RE: Marsh Landing Generating Station
Application for Certification 08-AFC-03

Responses to Data Request Set 2: (#60–63)

Application for Certification (08-AFC-03) for MARSH LANDING GENERATING STATION Contra Costa County, California

Technical Area: Biological Resources
Author: Heather Blair

Figure 60-1

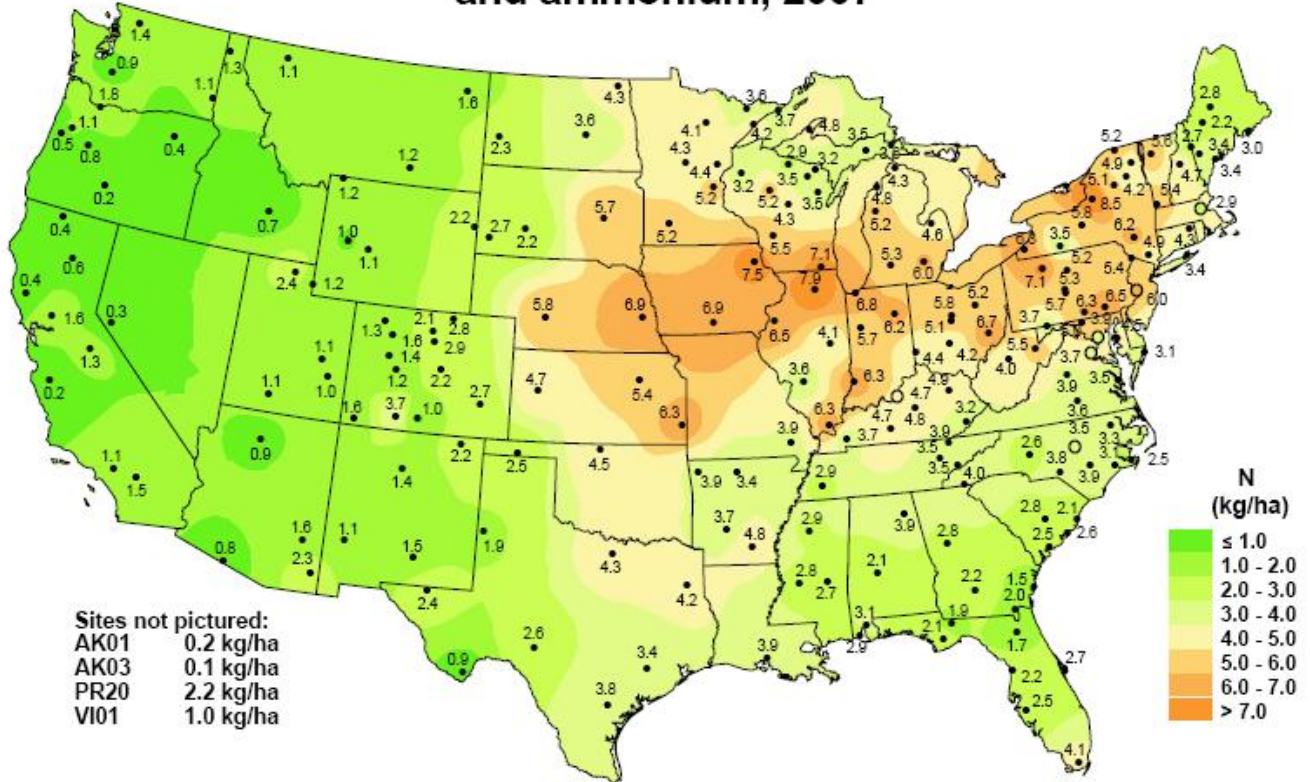
60. *Please quantify the existing baseline total nitrogen deposition rate in the vicinity of MLGS (encompassing the areas listed in DR #2) in kilograms per hectare per year (kg/ha/yr). Provide the complete citation for references used in determining this number.*

Based on data from the National Atmospheric Deposition Program, National Trends Network at The University of Illinois Urbana-Champaign (NADP, 2007), the wet nitrogen deposition rate in the vicinity of the Marsh Landing Generating Station (MLGS), including the Antioch Dunes National Wildlife Refuge (NWR), was approximately 1.6 kilograms per hectare per year (kg/ha/yr) in 2007. Wet nitrogen deposition is used as a proxy for total nitrogen deposition because dry deposition rates are generally low and monitoring techniques for dry deposition are less reliable (RMNP, 2006). Figure 60-1 shows wet measured nitrogen deposition values across the country from the National Atmospheric Deposition Program. The background value of 1.6 kg/ha/yr is based on actual measured data from a deposition monitoring station in Davis, California, operated by the U.S. Geological Survey and the University of California-Davis.

Nitrogen Deposition Isopleth Map (kg/ha/yr)-Vegetation
 Marsh Landing Generating Station
 Mirant Marsh Landing, LLC
 Contra Costa County, California
 June 2009
 28067344
URS
FIGURE 62-1a

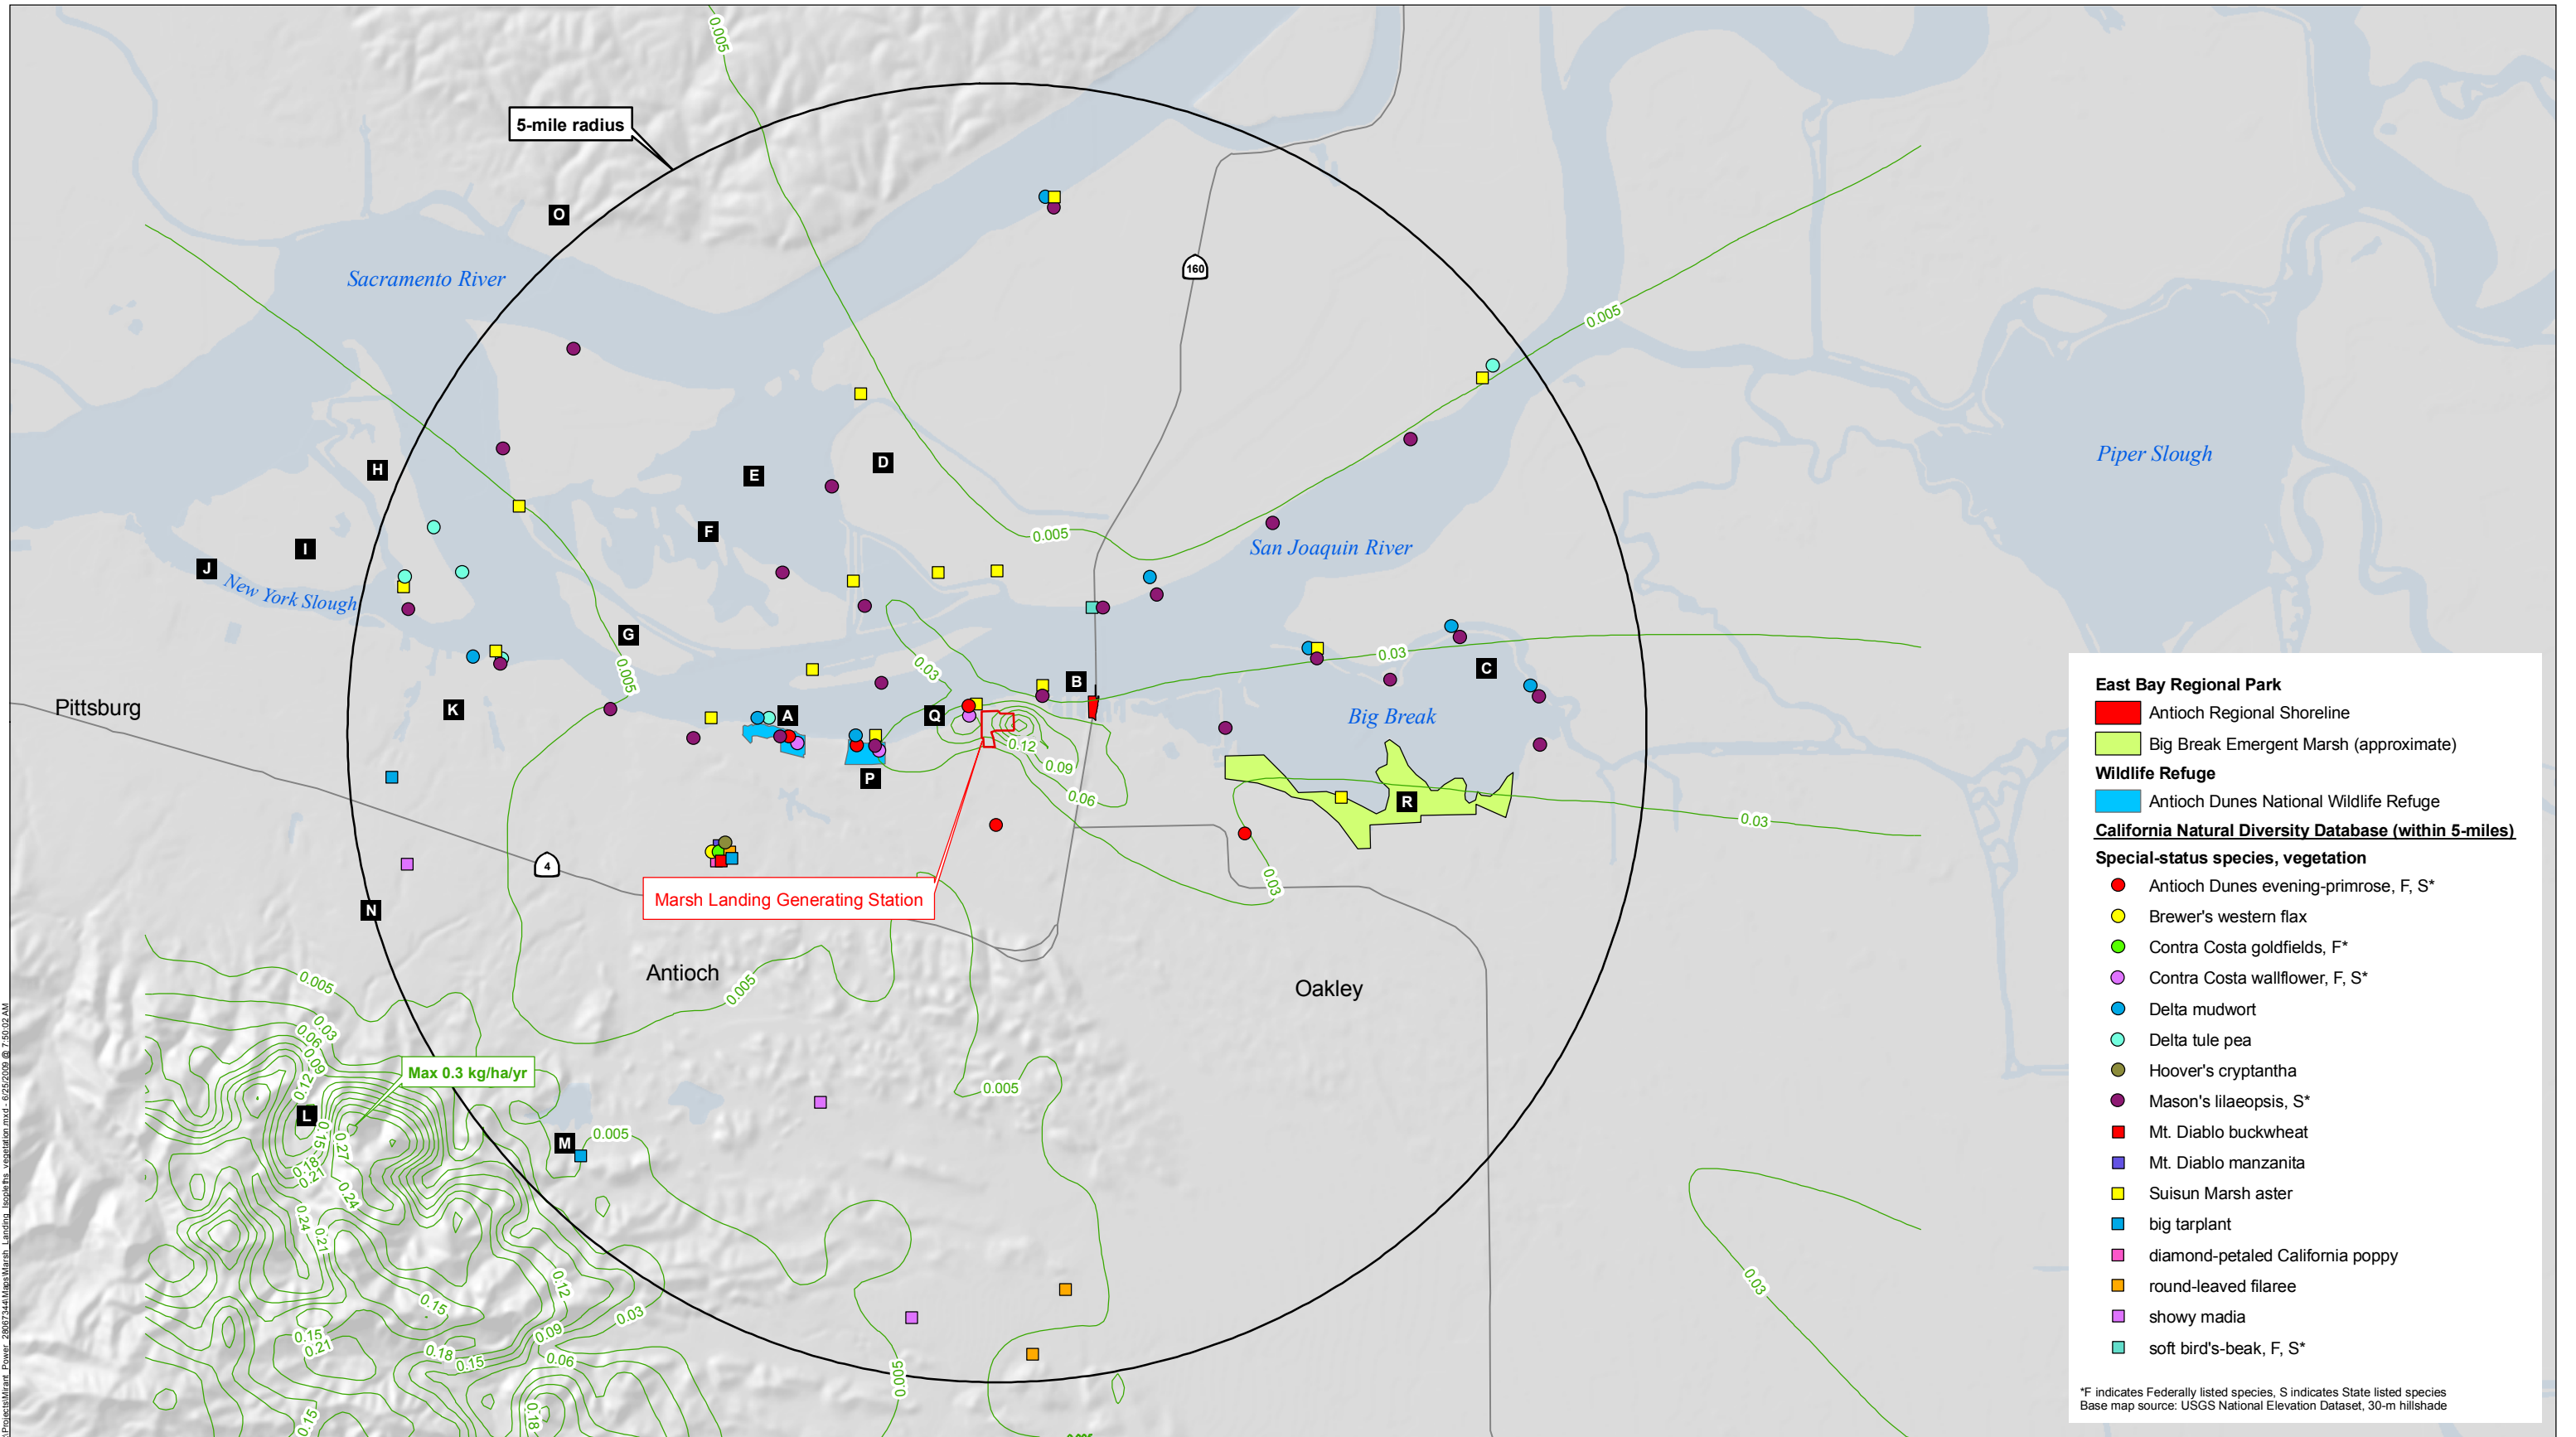
- 62. Provide an isopleth graphic over USGS 7.5-minute maps (or equally detailed map) of the direct nitrogen deposition rates caused by the project that graphically depicts the results.**

As illustrated in Figures 62-1a and 62-1b, nitrogen deposition rates from MLGS at the Sardis Unit and Stamms Unit of the Antioch Dunes NWR are between 0.005 and 0.03 kg/ha/yr. With background, the maximum nitrogen deposition rate for the Antioch Dunes Wildlife Refuge is 1.63 kg/ha/yr.

In the freshwater/brackish marsh habitat north of the project area along the San Joaquin River shoreline, nitrogen deposition rates are between 0.06 and 0.09 kg/ha/yr. With added background, the maximum modeled nitrogen deposition rate for this area is estimated to be 1.69 kg/ha/yr. Tidal marshes have high biomass production and accumulation, in addition to tidal processes that help control nutrient fluxes. They also have nitrogen fluxes an order of magnitude higher than many other systems and are not particularly sensitive to nitrogen deposition (Rozema et al., 2000).

Figures 62-1a and 62-1b provide the isopleths for nitrogen deposition rates due to the proposed project. Figure 62-1a shows the federal and state listed special-status vegetation species. Figure 62-1b shows the federal and state listed wildlife special-status species.

FIGURE 63-1a

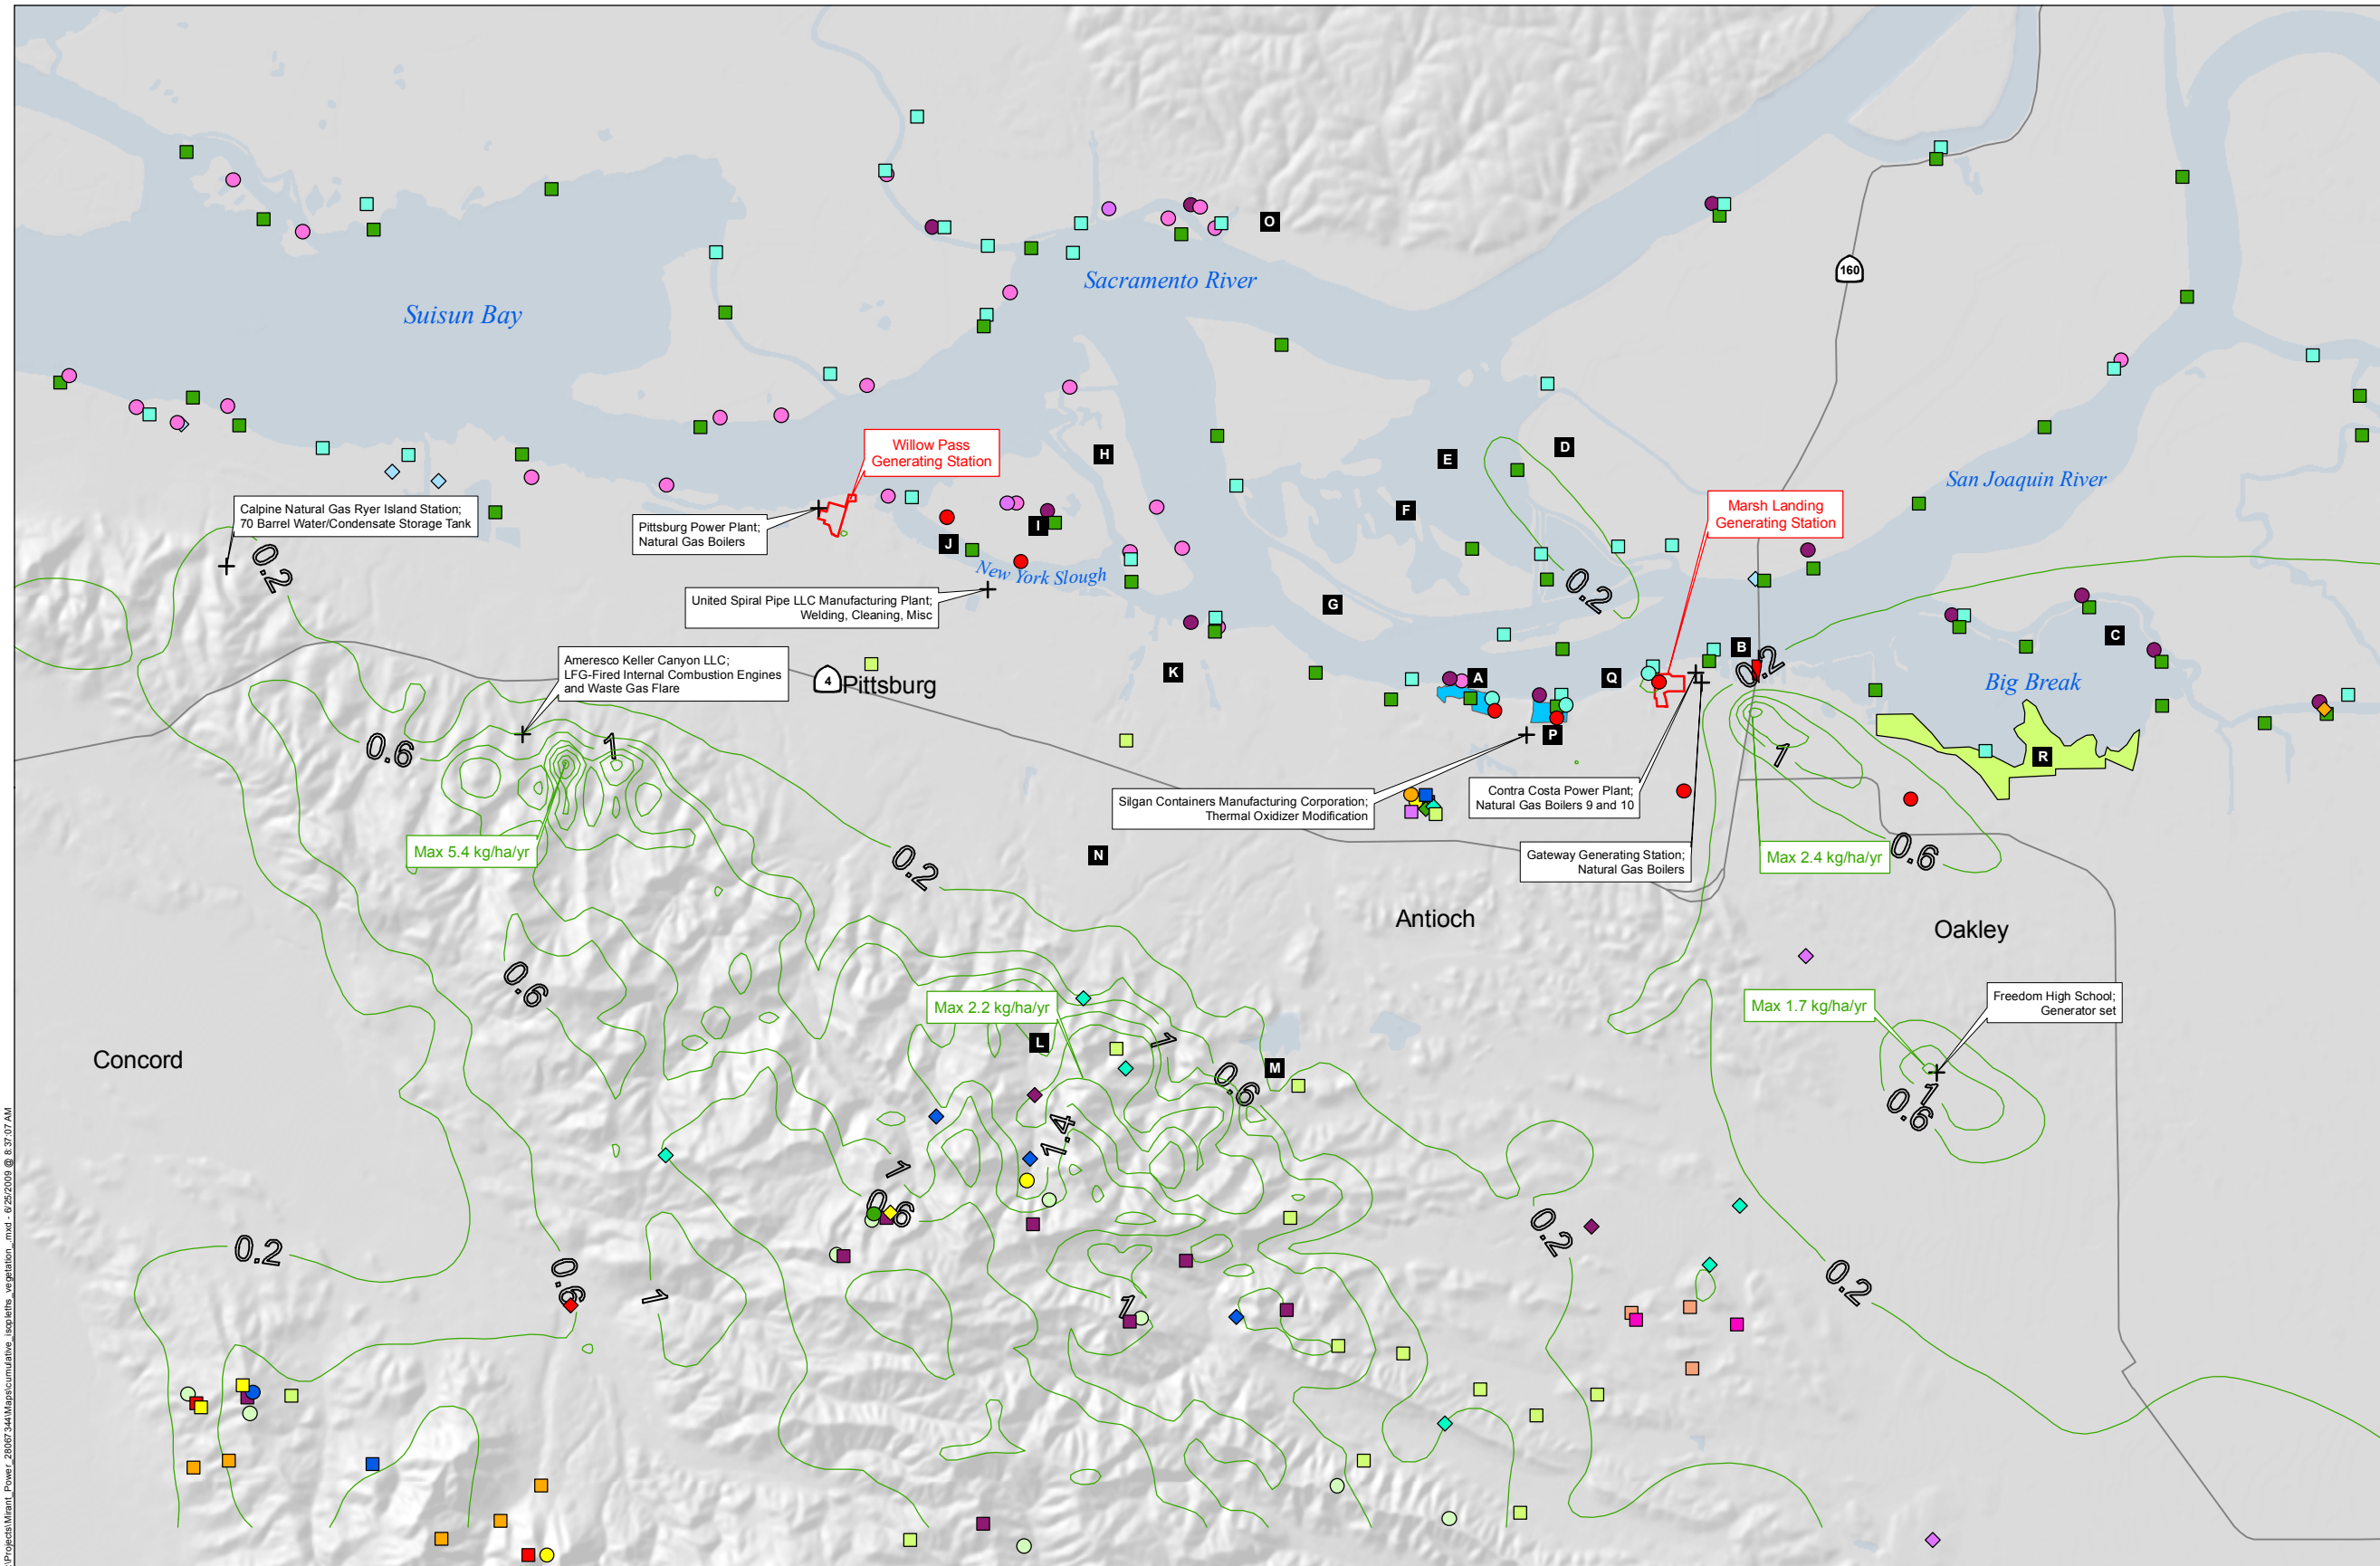
- 63. Please update the cumulative impact analysis (Tables 9-1 and 9-2) in Responses to Data Request Set #1 (Data Request #9) with nitrogen deposition values in kg/ha/yr. Provide an isopleth graphic over USGS 7.5-minute maps (or equally detailed map) of the direct nitrogen deposition values in the cumulative analysis.**

Figures 63-1a and 63-1b provide the isopleths for nitrogen deposition rates in kg/ha/yr due to all cumulative sources listed in Table 63-1. Figure 63-1a shows the federal and state listed special-status vegetation species. Figure 63-1b shows the federal and state listed special-status wildlife species.

As seen in Figures 63-1a and 63-1b, the maximum cumulative nitrogen deposition value occurs in the hills south of Pittsburg, which is located more than 9 miles southwest of the MLGS project site. The maximum nitrogen deposition rate for all cumulative sources is estimated to be 5.4 kg/ha/yr (without background) near the Ameresco Keller Canyon facility. This is the only area that would exceed the benchmark of 5 kg/ha/yr with background; however this area is not considered sensitive to nitrogen deposition since sands or serpentine soils are not known to be present. Approximately 98 percent of the highest nitrogen deposition rates in these hills are caused by nitrous oxide emissions from sources at the Ameresco Keller Canyon LLC facility, which includes two landfill gas-fired internal combustion engines and a waste gas flare.

- An area near the Black Diamond Mines Regional Preserve (Area L on the figures)
- An area around the Freedom High School Generator
- An area southeast of MLGS west of Big Break Marsh (Area R on the figures) and south of the Antioch Shoreline (Area B on the figures)

Cumulative nitrogen deposition values in the hills near Black Diamond Mines Regional Preserve (Area L on the figures) are largely associated with ammonia emissions from the Gateway Generating Station. The maximum value in this area without background is 2.2 kg/ha/yr.
